**Appendix 1: Wiltshire Housing Site Allocations Plan (WHSAP)**  
**Consolidated Schedule of Recommended Main Modifications (December 2019)**

# Inset Map Amendments

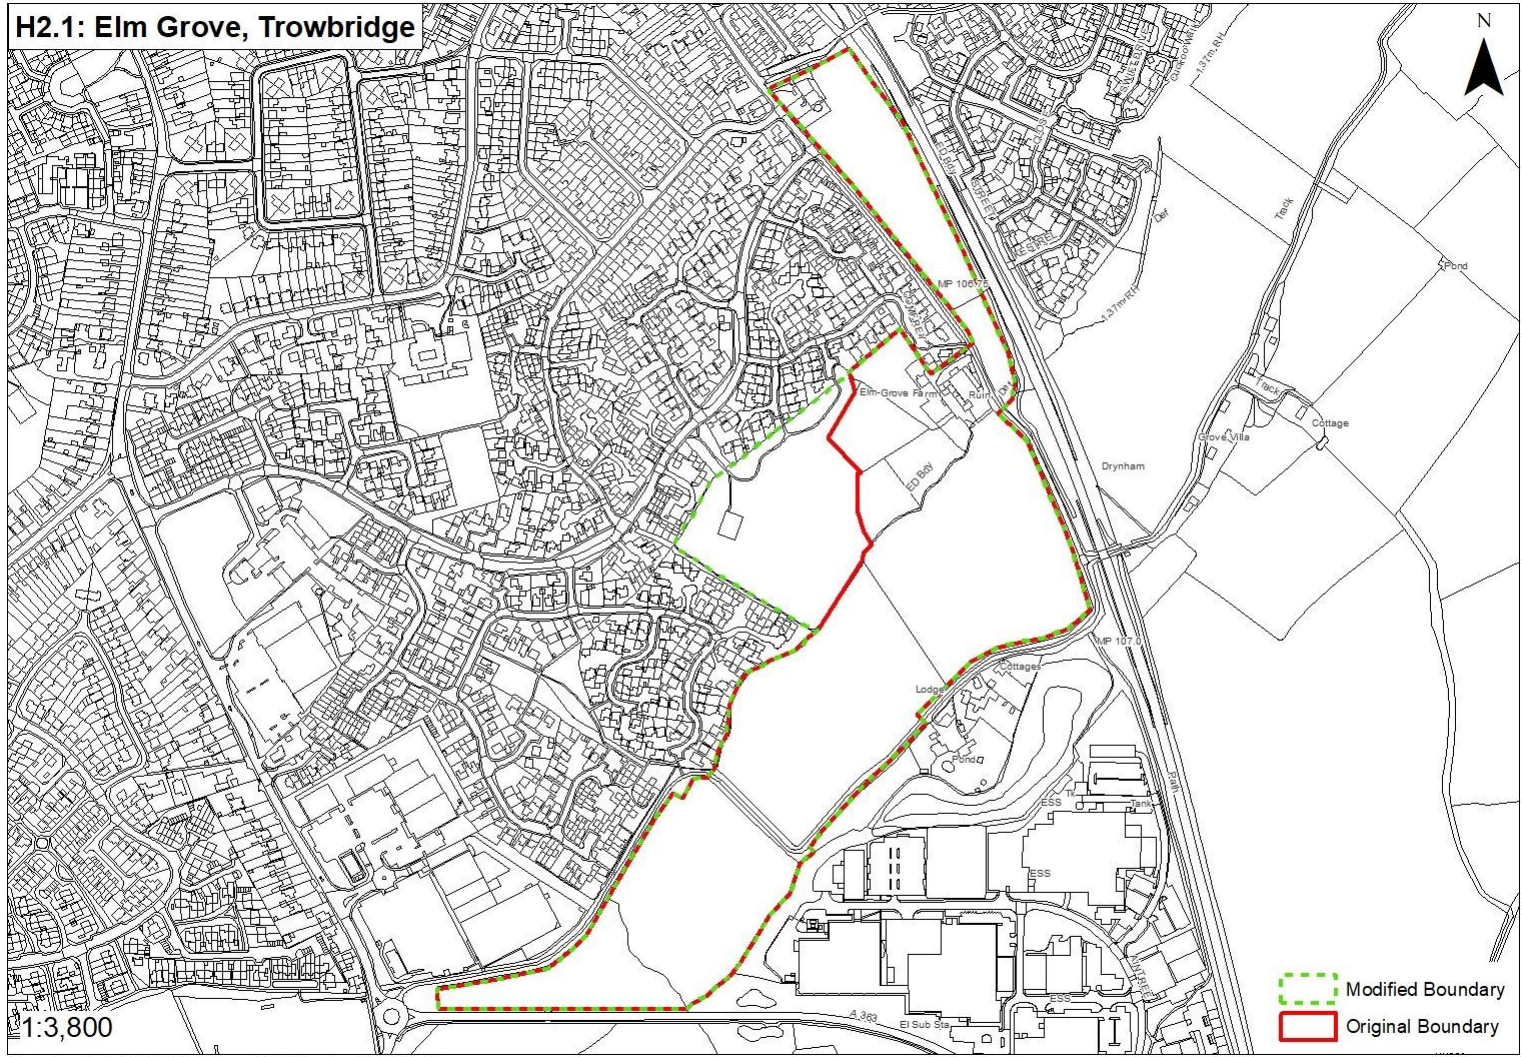
MM31	Figure 5.5	PC54	Amend Figure 5.5 (see end of schedule - Map 'H2.1: Elm Grove, Trowbridge' )
MM32	Insert new policy	FMM 14	New policy for H2.2 as follows:  <b><u>Land off A363 at White Horse Business Park, as identified on the Policies Map, is allocated for development comprising the following elements:</u></b>  <ul style="list-style-type: none"> <li>• <b><u>approximately 175 dwellings;</u></b></li> <li>• <b><u>vehicular access from the A363;</u></b></li> <li>• <b><u>development to be directed to the north and east of the site; and</u></b></li> <li>• <b><u>improvements to cycling and walking routes through the site to link into the existing network.</u></b></li> </ul> <b><u>Development will be subject to the following requirements:</u></b>  <ul style="list-style-type: none"> <li>• <b><u>core bat habitat will be protected and enhanced. Design and layout will be informed by appropriate surveys, impact assessments and the Trowbridge Bat Mitigation Strategy (TBMS);</u></b></li> <li>• <b><u>appropriate mitigation to protect bats, including financial contributions towards management, monitoring and any off-site measures as necessary, as informed by the TBMS;</u></b></li> <li>• <b><u>retention and enhancement of existing hedgerows and trees as part of wider landscaping and green infrastructure requirements, incorporating open space provision. Development will be expected to enhance a key gateway approach to the town and retain visual separation between the town and North Bradley;</u></b></li> </ul>

## H2.2: Land off A363 at White House Business Park, Trowbridge

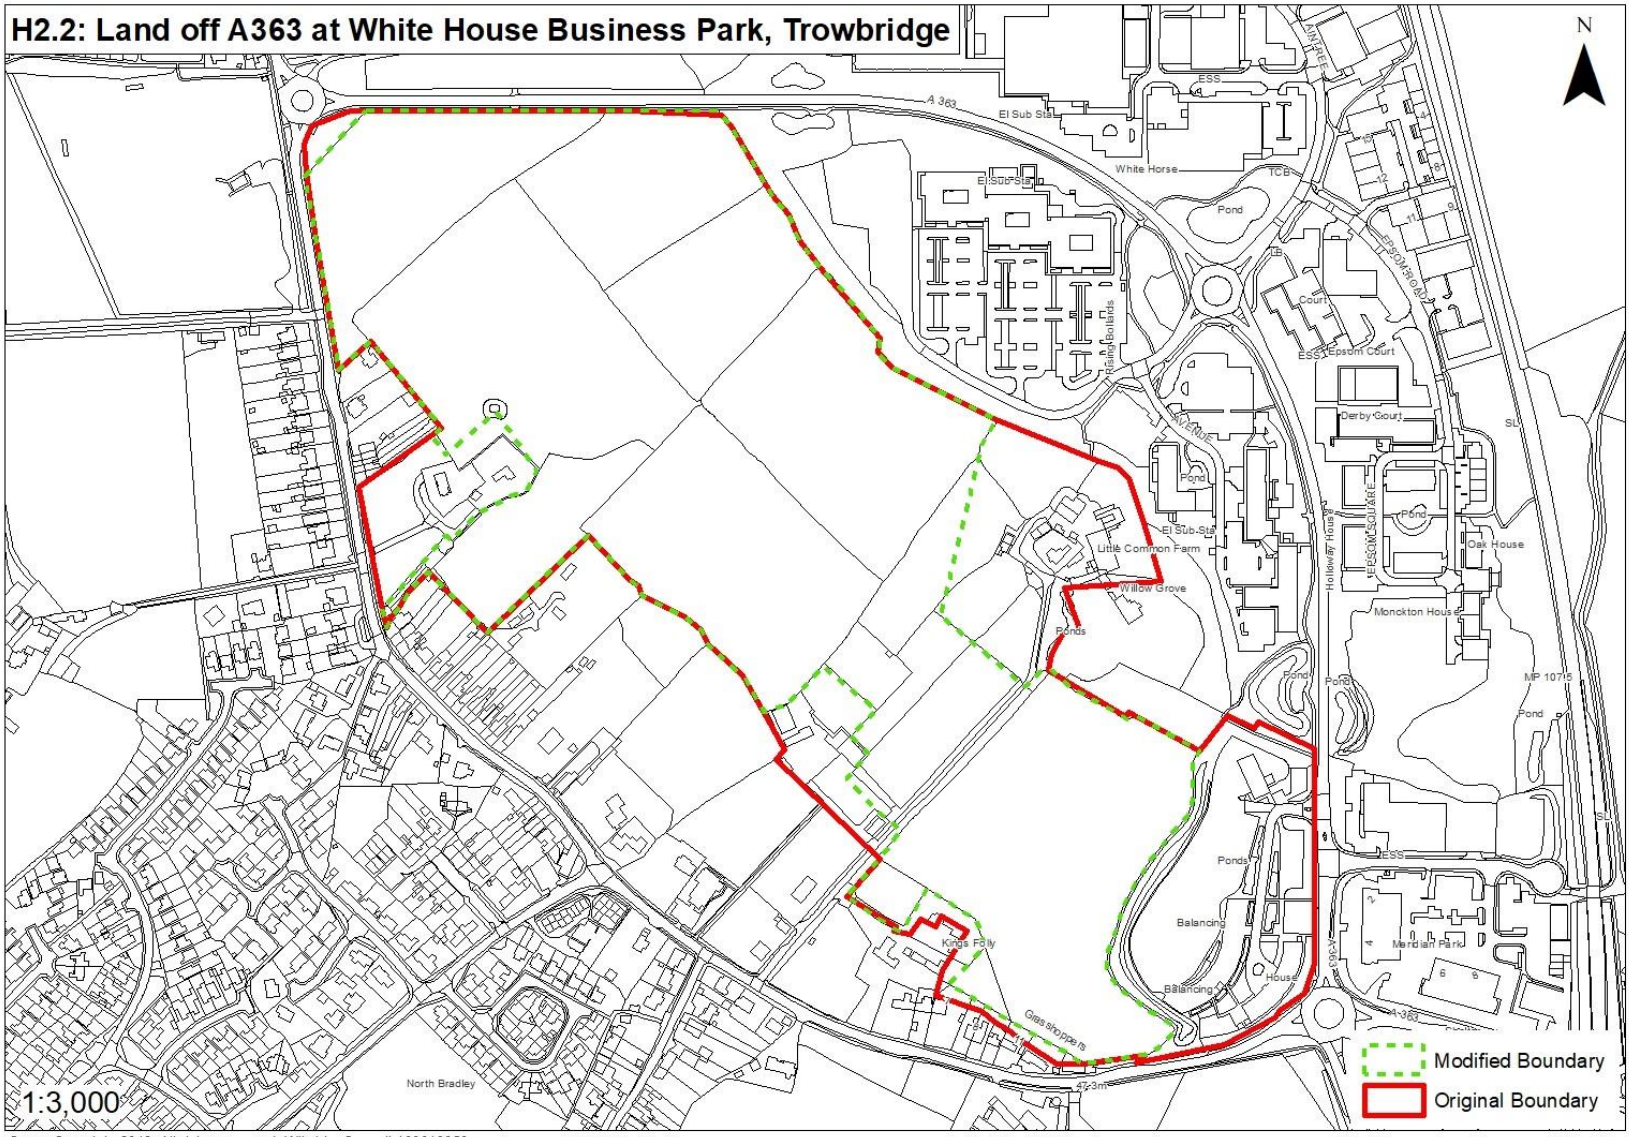
<p><del>where needed to increase capacity at</del> local GP surgeries and dentistry at the town <u>in accordance with core policies of the Wiltshire Core Strategy.</u></p>
MM39	Figure 5.6	PC 59	Amend Figure 5.6 (see end of Schedule - Map 'H2.2: Land off A363 White Horse Business Park, Trowbridge')
MM40	Insert new policy Figure 5.7	FMM 19	<p>Insert new policy for H2.3 as follows:</p> <p><b><u>Land to the South West of Elizabeth Way, as identified on the Policies Map, is allocated for development comprising the following elements:</u></b></p> <ul style="list-style-type: none"> <li>• <b><u>approximately 355 dwellings;</u></b></li> <li>• <b><u>vehicular access points from Elizabeth Way; and</u></b></li> <li>• <b><u>improvements to cycling and walking routes through the site to link into the existing network.</u></b></li> </ul> <p><b><u>Development will be subject to the following requirements:</u></b></p> <ul style="list-style-type: none"> <li>• <b><u>core bat habitat will be protected and enhanced. Design and layout will be informed by appropriate surveys, impact assessments and the Trowbridge Bat Mitigation Strategy (TBMS);</u></b></li> <li>• <b><u>appropriate mitigation to protect bats, including financial contributions towards management, monitoring and any off-site measures as necessary, as informed by the TBMS;</u></b></li> <li>• <b><u>sensitive design and layout, which ensures the significance of heritage assets and their settings are not subject to unacceptable harm. This shall be informed by appropriate heritage and archaeological assessments;</u></b></li> <li>• <b><u>retention and enhancement of existing hedgerows and trees as part of wider landscaping and green infrastructure requirements, incorporating noise attenuation measures and open space provision; and</u></b></li> <li>• <b><u>a Flood Risk Assessment (incorporating an assessment of the predicted effects of climate change) and comprehensive drainage strategy to inform site layout and design so that surface water is controlled and does not exacerbate flooding off-site.</u></b></li> </ul> <p><b><u>Development will take place in accordance with a masterplan approved by the Council as part of the planning application process. The design and layout will take account of all policy requirements, including the timely and coordinated provision of necessary infrastructure to achieve a comprehensive development of the site.</u></b></p>

### H2.3: Elizabeth Way, Trowbridge

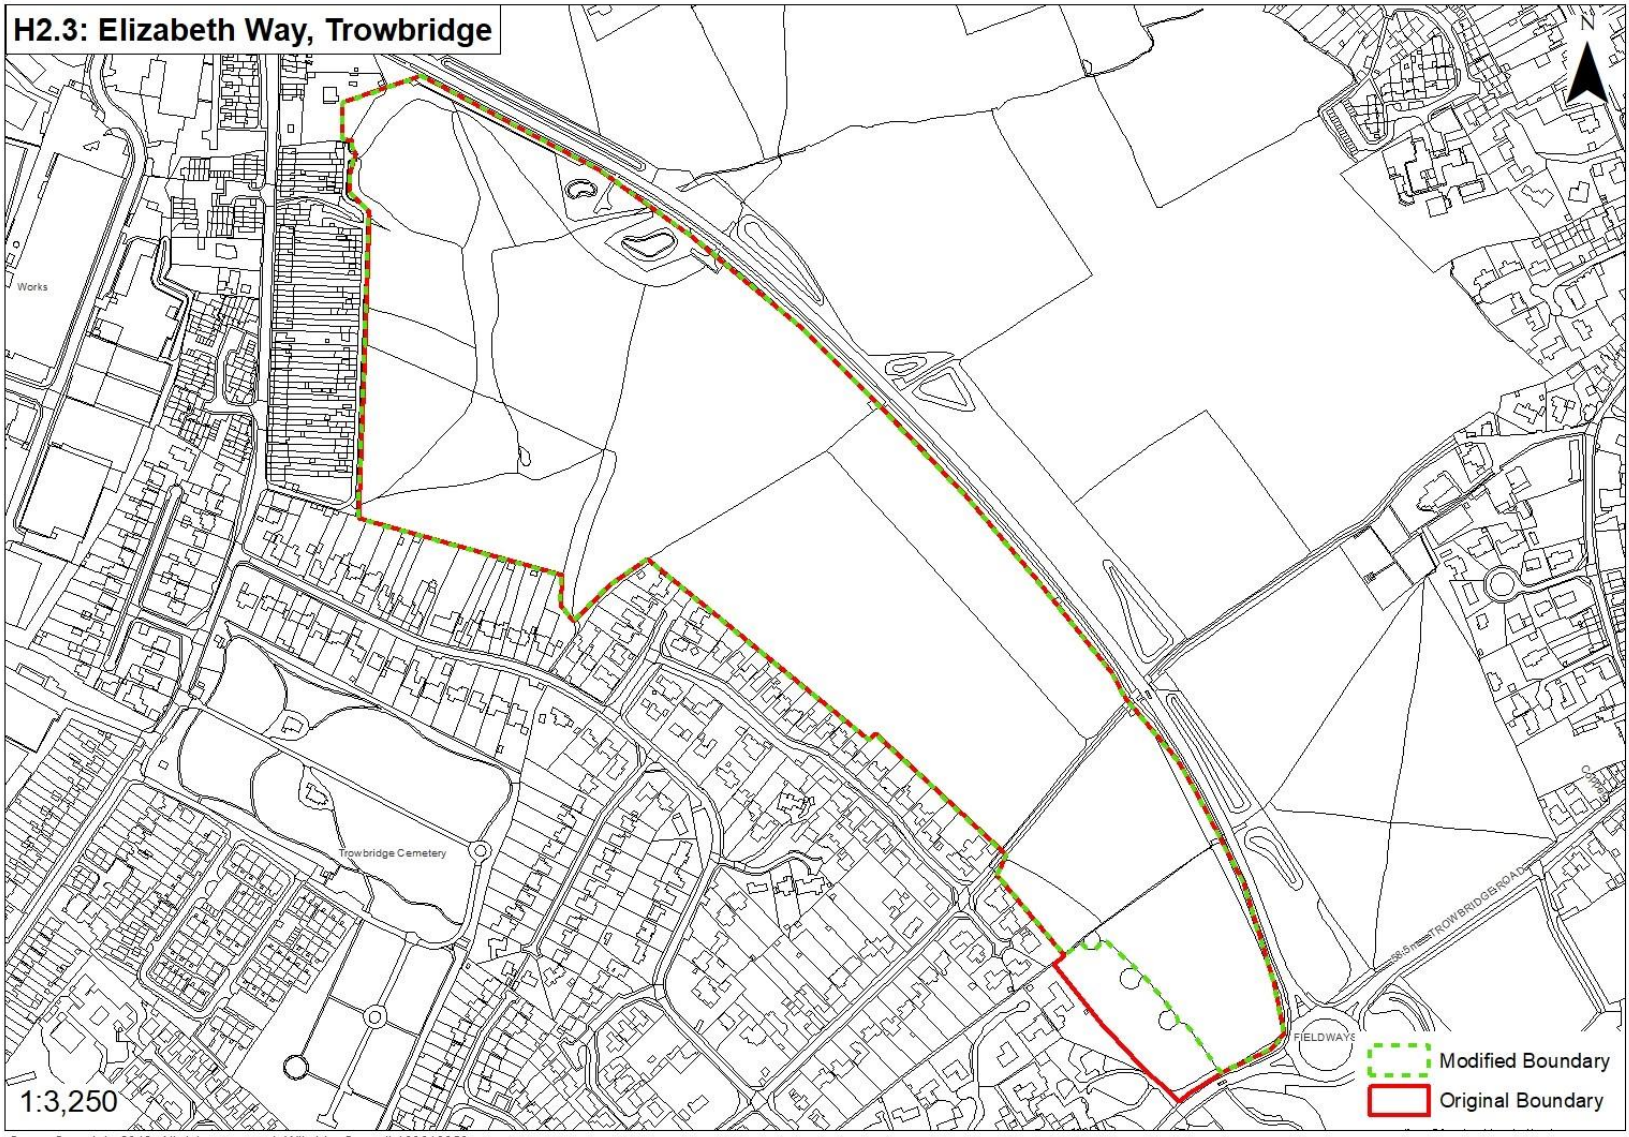
MM47	Figure 5.7	PC 63	Amend Figure 5.7 (see end of schedule – Map ‘H2.3: Elizabeth Way, Trowbridge’)
MM48	Insert new policy after Figure 5.8	FMM 23	<p>Insert new policy for H2.4 as follows:</p> <p><b><u>Land at Church Lane, as identified on the Policies Map, is allocated for development comprising the following elements:</u></b></p> <ul style="list-style-type: none"> <li>• <b><u>approximately 45 dwellings focused towards the north of the site;</u></b></li> <li>• <b><u>sensitively designed vehicular access via a new junction arrangement off the A361 that incorporates discreet lighting, signage and boundary treatments to avoid unacceptable harm to heritage assets and their settings; and</u></b></li> <li>• <b><u>improve cycling and walking routes through the site to link to the existing network, including links between the site, Southwick Country Park and the existing network, including footpath TROW8.</u></b></li> </ul> <p><b><u>Development will be subject to the following requirements:</u></b></p> <ul style="list-style-type: none"> <li>• <b><u>core bat habitat will be protected and enhanced. Design and layout will be informed by appropriate surveys, impact assessments and the Trowbridge Bat Mitigation Strategy (TBMS);</u></b></li> <li>• <b><u>appropriate mitigation to protect bats, including financial contributions towards management, monitoring and any off-site measures as necessary, as informed by the TBMS;</u></b></li> <li>• <b><u>retention and enhancement of hedgerows and trees as part of wider landscaping and green infrastructure requirements, and the creation of a publicly accessible Green Infrastructure corridor along the Lambrok Stream to protect and enhance the character,</u></b></li> </ul>

## H2.4: Church Lane, Trowbridge

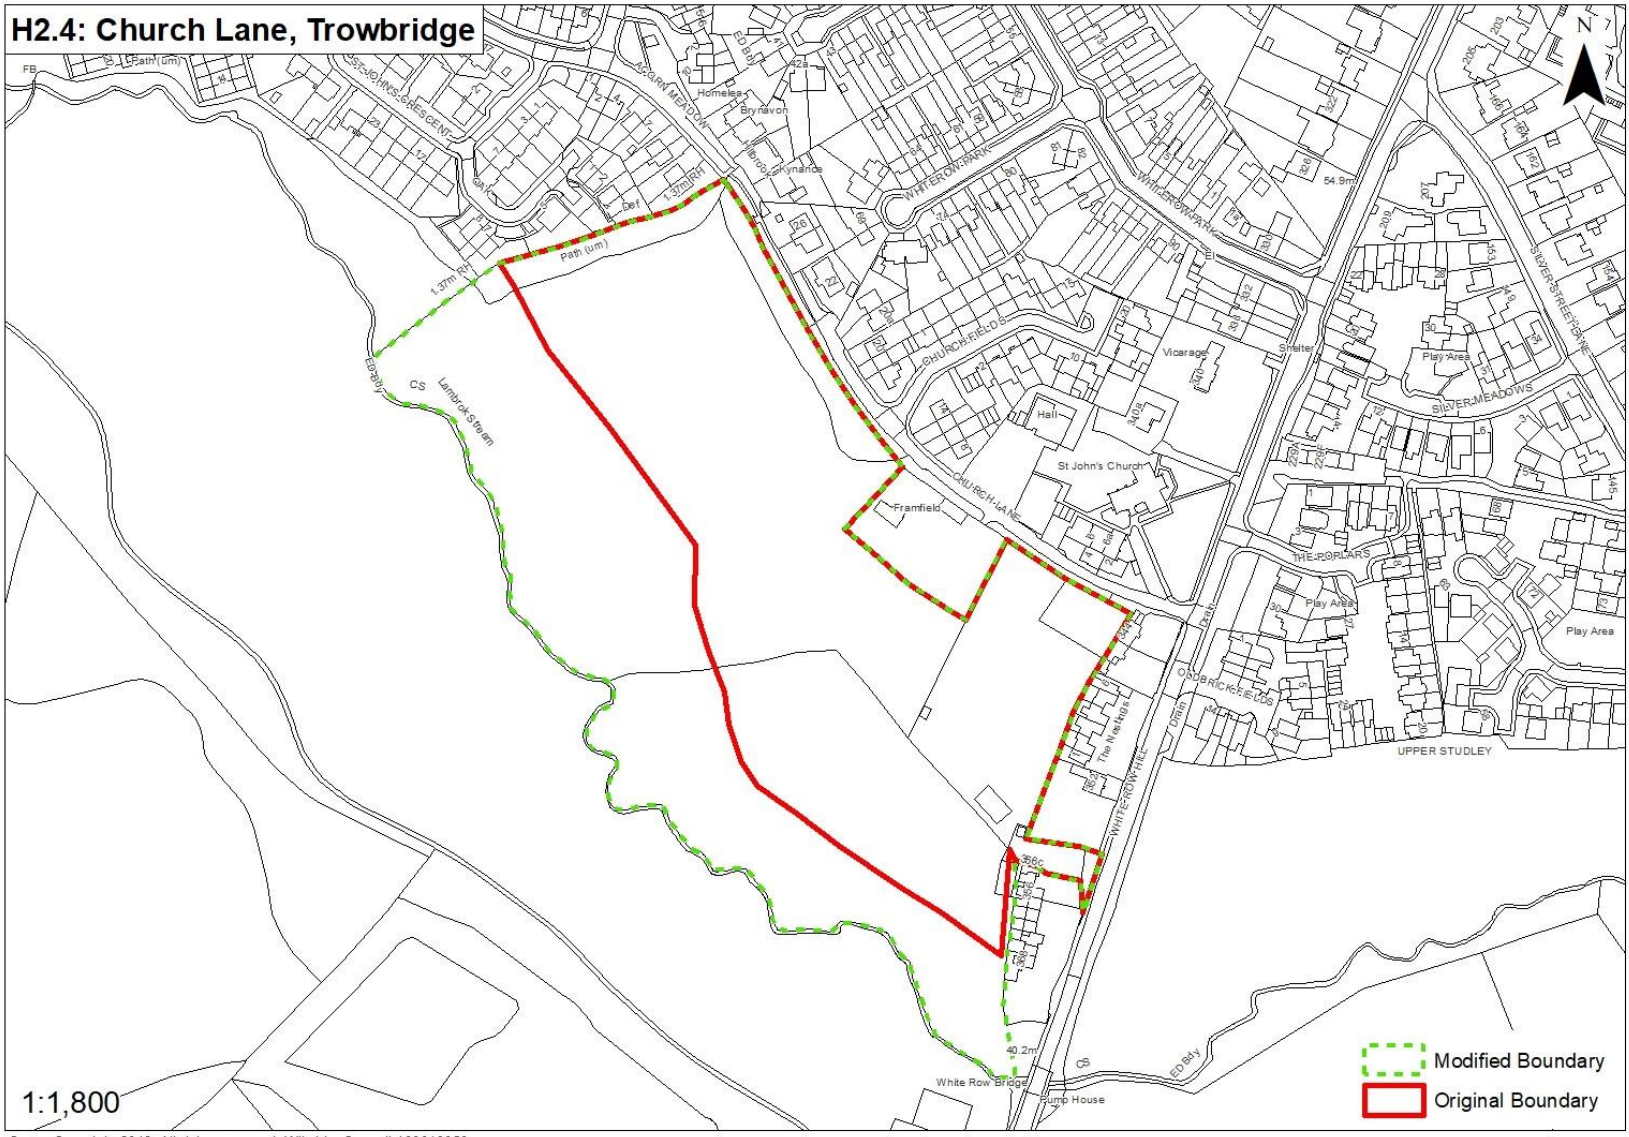
where needed to increase capacity at local GP surgeries and dentistry at the town <u>in accordance with core policies of the Wiltshire Core Strategy.</u>
MM55	Figure 5.6		Amend Figure 5.6 (see end of Schedule – Map ‘H2.4: Church Lane, Trowbridge’)
MM56	Insert new policy	FMM 29	<p>New policy for H2.5 as follows:</p> <p><b><u>Land at Upper Studley, as identified on the Policies Map, is allocated for development comprising the following elements:</u></b></p> <ul style="list-style-type: none"> <li>• <b><u>approximately 45 dwellings;</u></b></li> <li>• <b><u>vehicular access via a new junction arrangement off the A361; and</u></b></li> <li>• <b><u>improvements to cycling and walking routes through the site to link into the existing network.</u></b></li> </ul> <p><b><u>Development will be subject to the following requirements:</u></b></p> <ul style="list-style-type: none"> <li>• <b><u>core bat habitat will be protected and enhanced. Design and layout will be informed by appropriate survey, impact assessments and the Trowbridge Bat Mitigation Strategy (TBMS);</u></b></li> <li>• <b><u>appropriate mitigation to protect bats, including financial contributions towards management, monitoring and any off-site measures as necessary, as informed by the TBMS;</u></b></li> <li>• <b><u>an attractive frontage to A361 and enhancement of this approach to the town;</u></b></li> <li>• <b><u>retention and enhancement of existing hedgerows and trees as part of wider landscaping and green infrastructure requirements, and the creation of a publicly accessible Green Infrastructure corridor along the Lambrok Stream to protect and enhance the character, biodiversity and amenity provided by Southwick Country Park in conjunction with development at Southwick Court and Church Lane; and</u></b></li> <li>• <b><u>a Flood Risk Assessment (incorporating an assessment of the predicted effects of climate change) and comprehensive drainage strategy to inform site layout and design so that surface water is controlled and does not exacerbate flooding off-site.</u></b></li> </ul> <p><b><u>Development will take place in accordance with a masterplan approved by the Council as part of the planning application process. The design and layout will take account of all policy requirements, including the timely and coordinated provision of necessary infrastructure to achieve a comprehensive development of the site. Any cumulative issues associated with heritage, landscape, biodiversity and highway access should be considered on a comprehensive</u></b></p>
